CHANGE ISSUE

ASA MASPS REV -

| Short Title for Change Issue: | Display of position uncertainty, R_{NAC} |

Figure 1: Indicating Position Uncertainty on a CDTI Display.

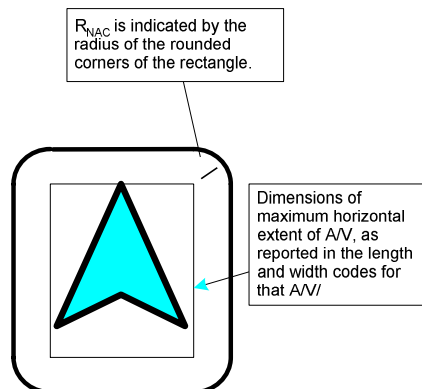
| <u>Issue Description:</u> It has been proposed to <i>require</i> that all traffic targets for which the NAC_P code is too small (e.g., $NAC_P < 5$, EPU or HFOM ≥ 1 NM) <i>must</i> be removed from the CDTI display. I would like to relax this proposed requirement, so as to permit an alternative, as described below. | | | | | | | | |

For traffic targets with non-zero NAC_P codes, permit the CDTI display to show the target's position uncertainty. One way to do this might be to draw a circle with radius R_{NAC} around the target, where R_{NAC} is the least upper bound on the EPU value for the NAC_P being reported by that target. Figure 1 shows how this might be done.

If R_{NAC} , the maximum EPU (Estimated Position Uncertainty) for a traffic target's the NAC code, is large compared to the symbol for that target on the CDTI display, the uncertainty in target position might be represented by a circle with center at the reported position of that target.

The CDTI should only be required to remove a target from the display (a) if $NACP = 0$, for which RNAC is infinite, or (b) if the circle(or rounded rectangle) with radius RNAC does not fit on the display, or (c) if RNAC is excessive and the CDTI designer did not exercise the option of showing the target's RNAC value.
